Subject: Transmittal of Class 1 Permit Modification to Update Figures in the Los Alamos National Laboratory (LANL) Hazardous Waste Facility Permit, EPA ID No. NM0890010515

**CLASS 1 PERMIT MODIFICATION NOTIFICATION
STRUCTURE CHANGES AT TECHNICAL AREA 54**

ENV-DO-14-0023

LAUR-13-29257

Figure 33: Technical Area (TA)-54, Area G, Pad 6, (Domes 153 & 283)

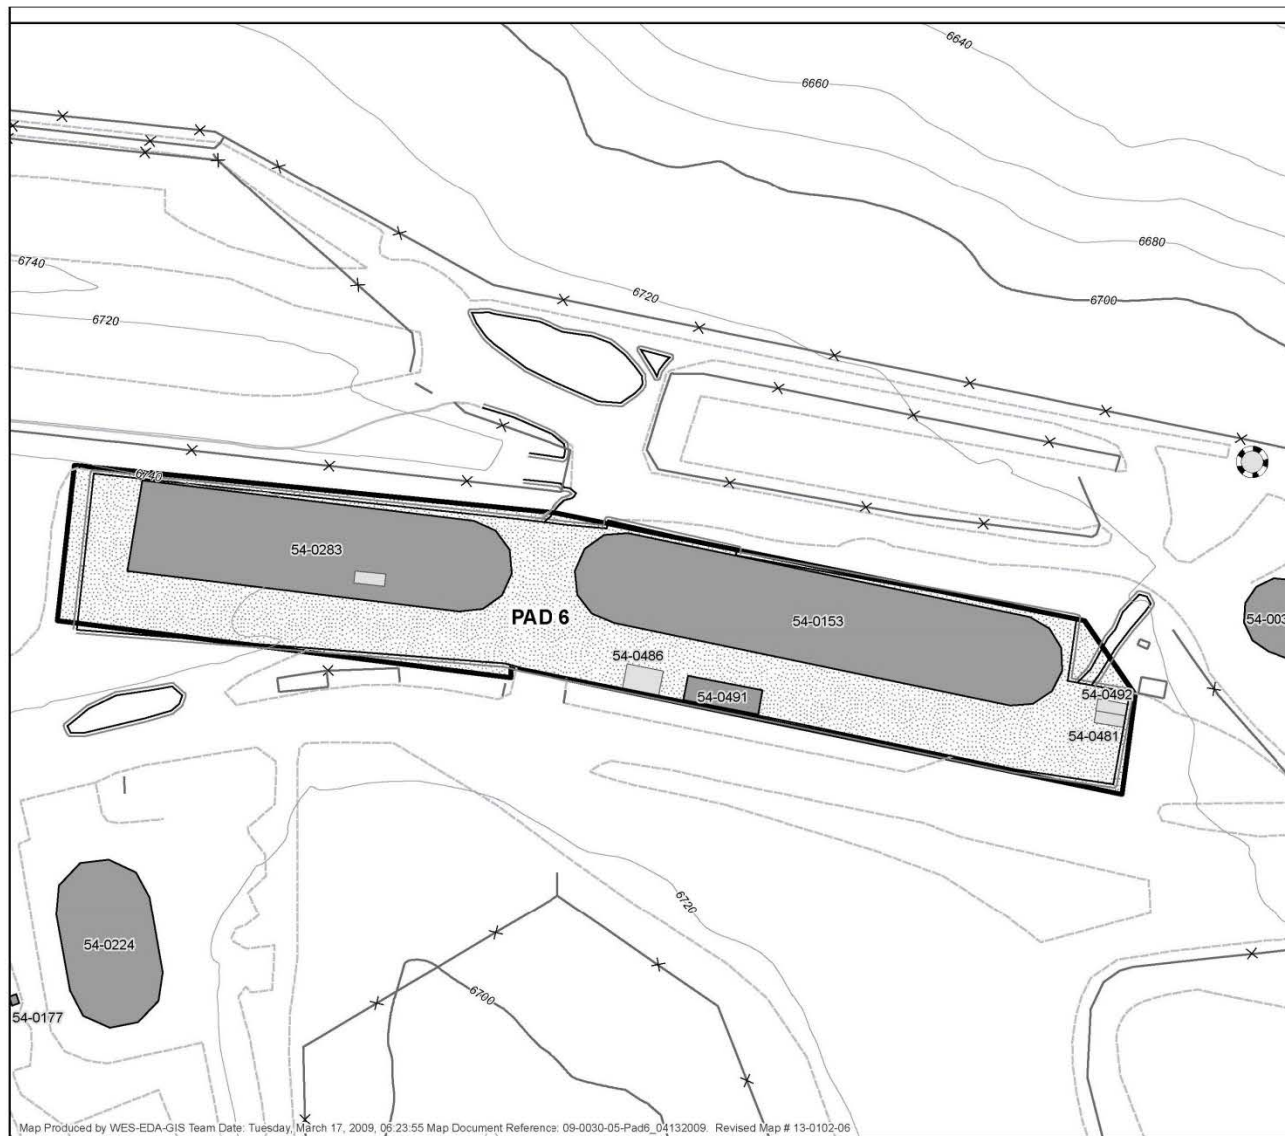
Figure G.9-1 (Technical Area 54, Area G, Pad 6 Outdoor Container Storage Unit Sampling Grid and Additional Sampling Locations) of Attachment G.9 and Figure 33 (Technical Area (TA)-54, Area G, Pad 6, (Domes 153 & 283)) of Attachment N were revised to remove structures 54-522 and 54-523. These structures were designated as structures that were not associated with the permitted unit and were not used to manage hazardous waste. The figure was also updated to reflect the addition

of a structure on the inside of structure 54-0283 that is not used to manage hazardous waste at the permitted unit.

Figure G.10-1: Technical Area 54, Area G, Pad 9 Outdoor Container Storage Unit Grid Sampling and Additional Sampling Locations

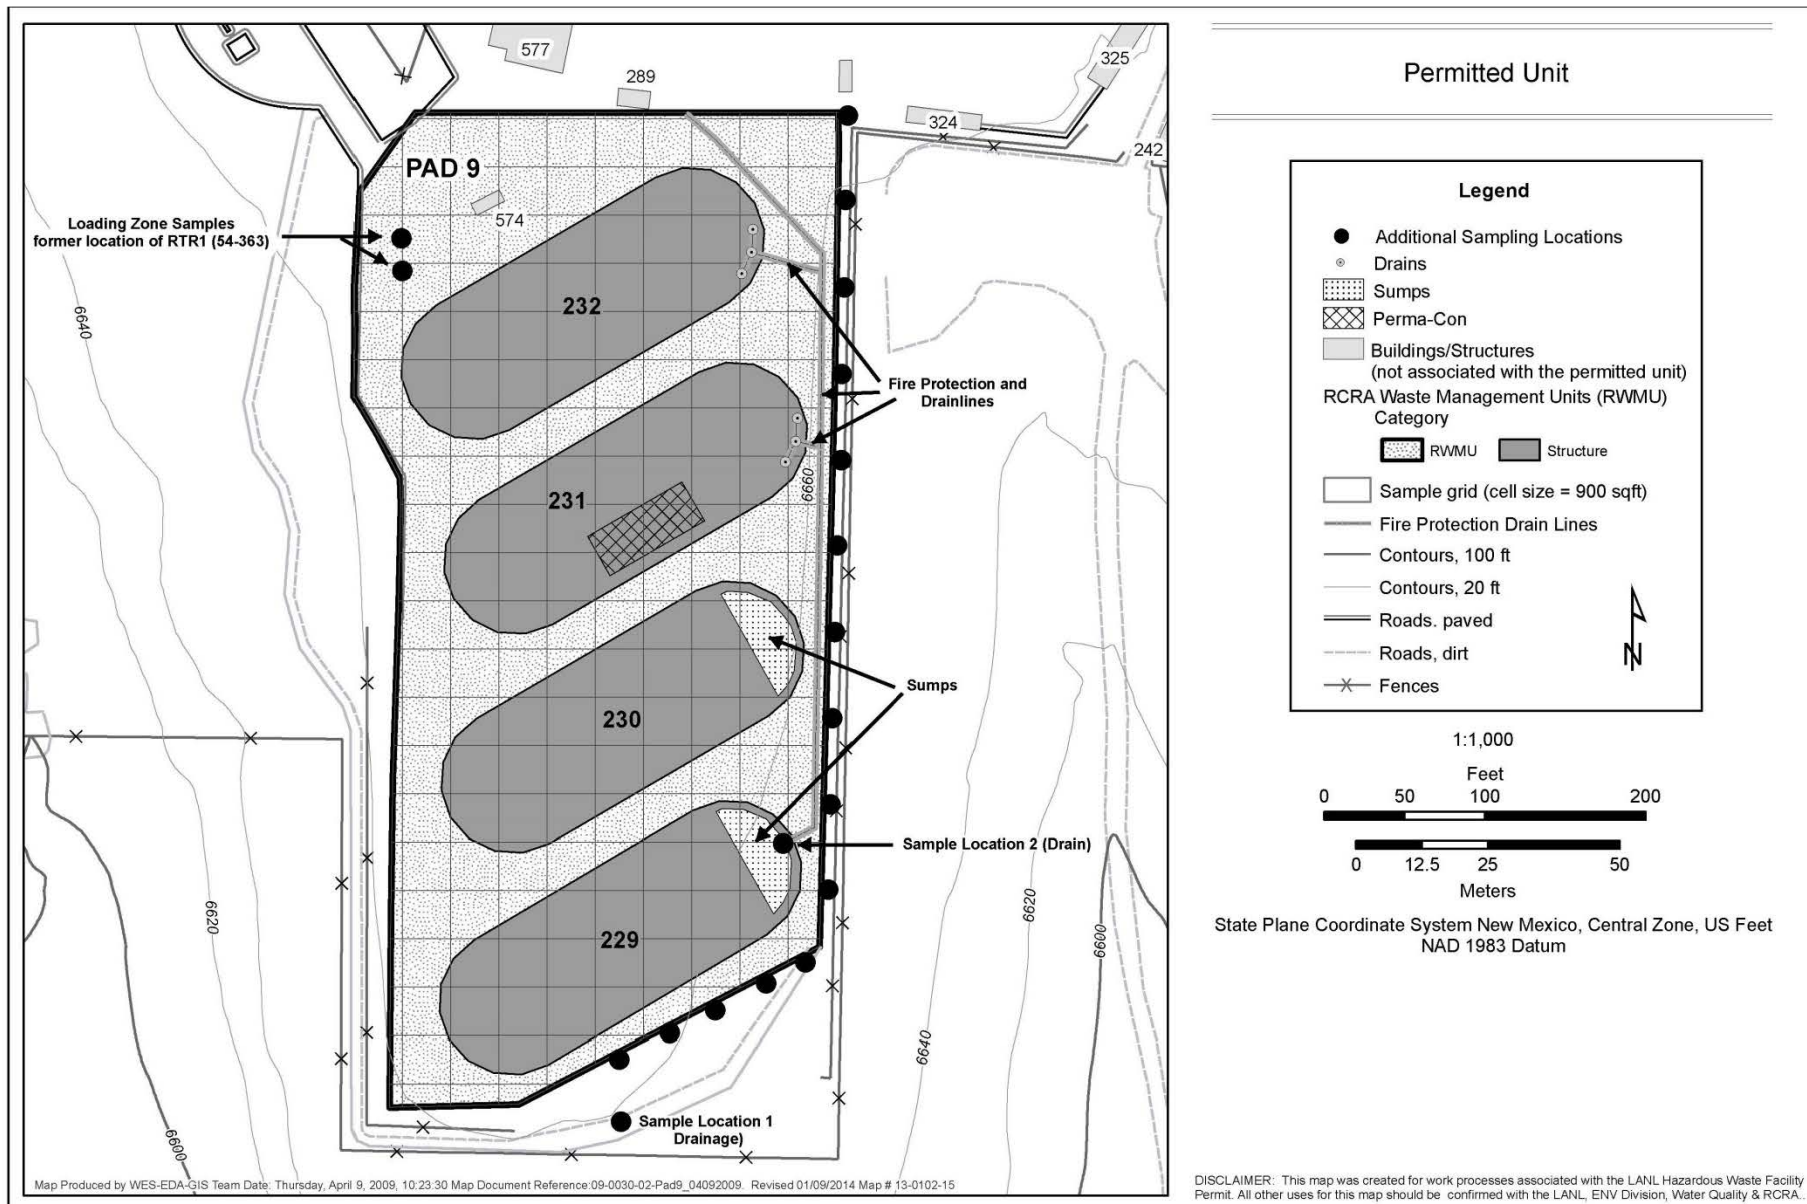
Figure G.10-1 (Technical Area 54, Area G, Pad 9 Outdoor Container Storage Unit Grid Sampling and Additional Sampling Locations) of Attachment G.10 and Figure 28 (Technical Area (TA)-54 Area G, Pad 9, (TWISP Domes 229, 230, 231 & 232)) of Attachment N were revised to remove storage shed 54-484 from Pad 9 and to show that storage shed 54-574 was relocated to an area northwest of Dome 232. These storage sheds are designated as structures that are not associated with the permitted unit and are not used to manage hazardous waste.

Figure G.12-1: Technical Area 54, Area G, Pad 11 Outdoor Container Storage Unit Grid Sampling and Additional Sampling Locations

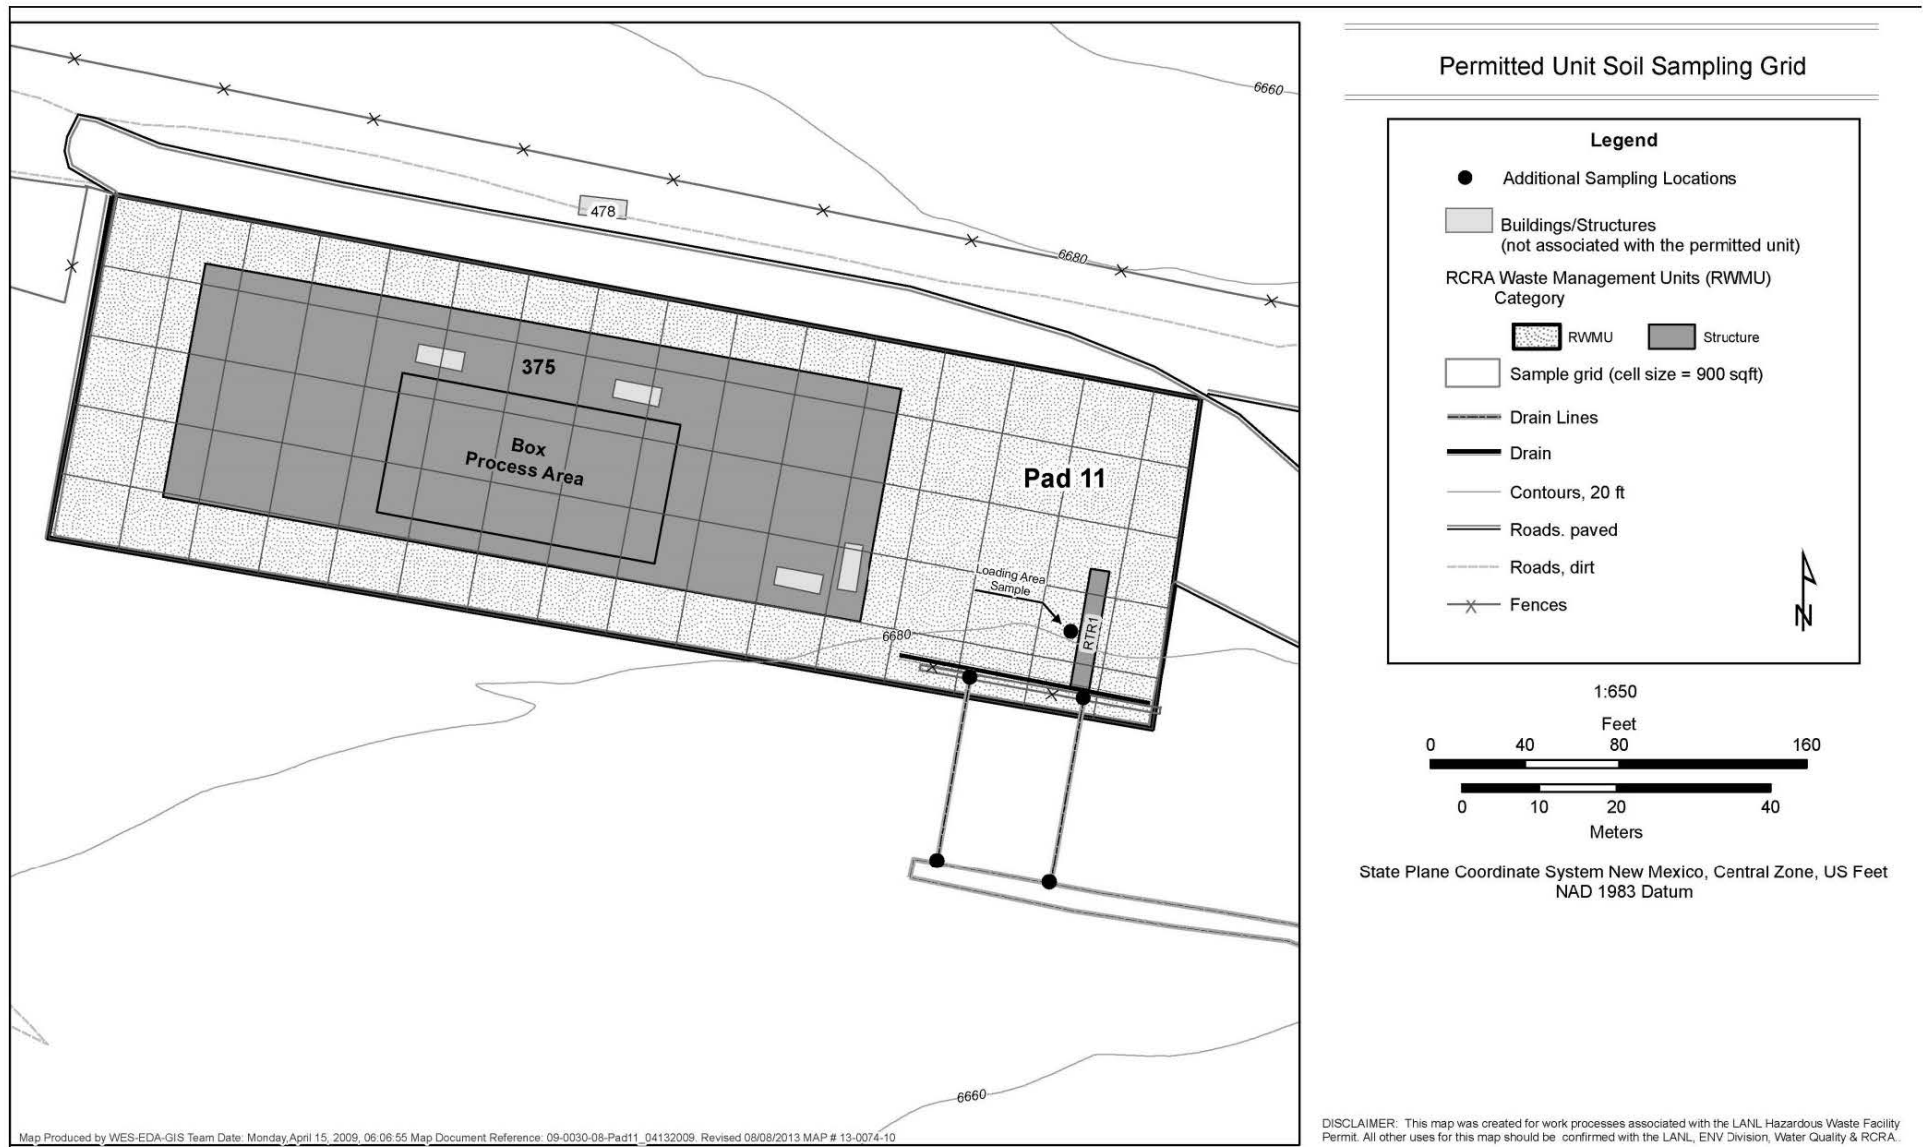
Figure G.12-1 (Technical Area 54, Area G, Pad 11 Outdoor Container Storage Unit Grid Sampling and Additional Sampling Locations) of Attachment G.12 and Figure 36 (TA-54, Area G, Pad 11) of Attachment N were revised to remove structure 54-57 from the southwest corner of the pad as well as the three concrete barricades (XXX3, XXX4 and XXX5) located on the northeast portion of the pad. Structure 54-57 was designated as a structure not associated with the permitted unit and it was not used to manage hazardous waste.

Figure G.17-1: Technical Area 54 West Outdoor Container Storage Unit Grid Sampling and Additional Sampling Locations

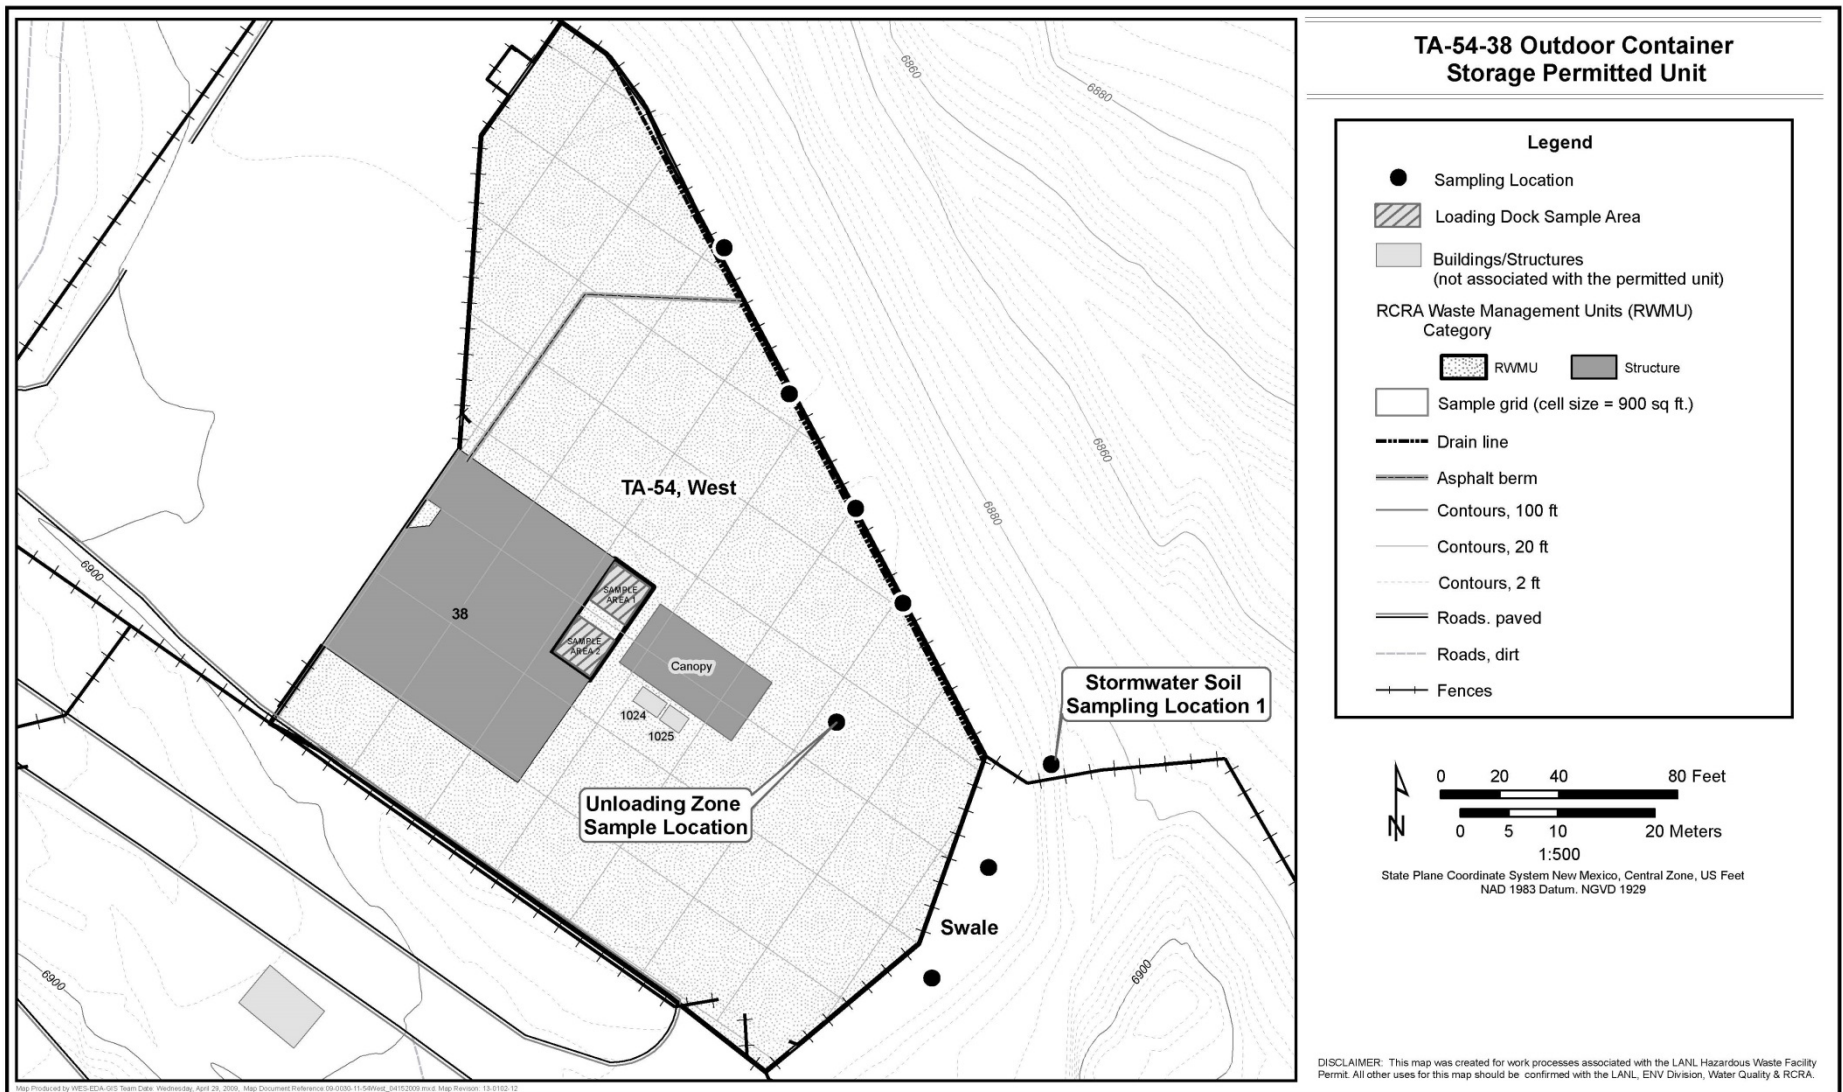
Figure G.17-1 (Technical Area 54, West Outdoor Container Storage Unit Grid Sampling and Additional Sampling Locations) of Attachment G.17 was revised to remove structures 54-34 and 54-455 (these structures were located outside of the permitted unit) and to make the fence line continuous along the northwest boundary of the permitted unit. Structure 54-34 previously served as part of the fence line boundary for the permitted unit. The structure was removed and the fence around the unit was completed to demarcate the boundary of the permitted unit.

Figure 9: Technical Area (TA) 54 West Location Map Showing Security Fences, Entry Gates, and Entry Stations

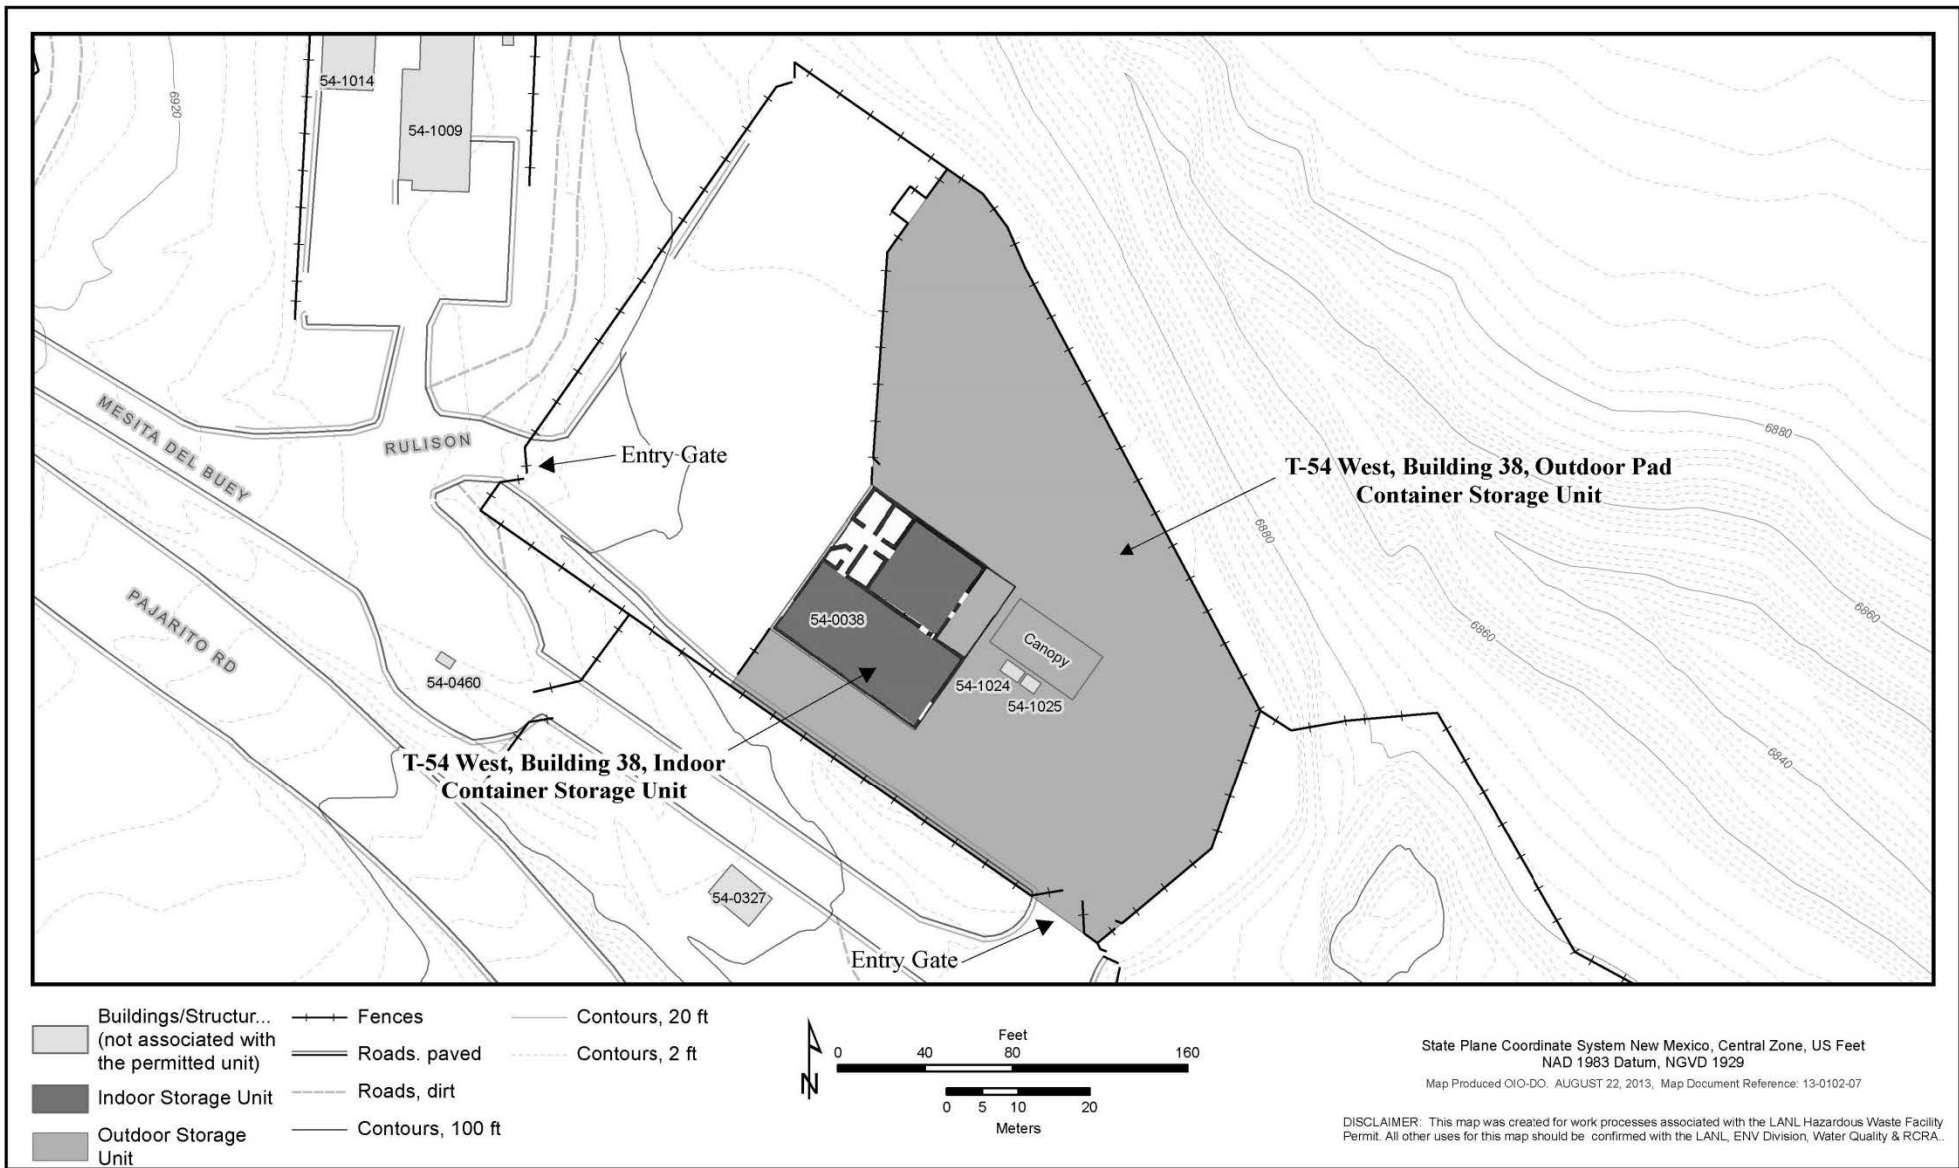
Figure 9 (Technical Area (TA) 54 West Location Map Showing Security Fences, Entry Gates and Entry Stations) and Figure 37 (Technical Area (TA) 54 West, Building 38 Indoor (High Bay and Low Bay) and Outdoor Pad) were revised to remove Structure 54-34 and to make the fence line continuous. Structure 54-34 previously served as part of the fence line boundary for the permitted unit. The structure was removed and the fence around the unit was completed to demarcate the boundary of the permitted unit.
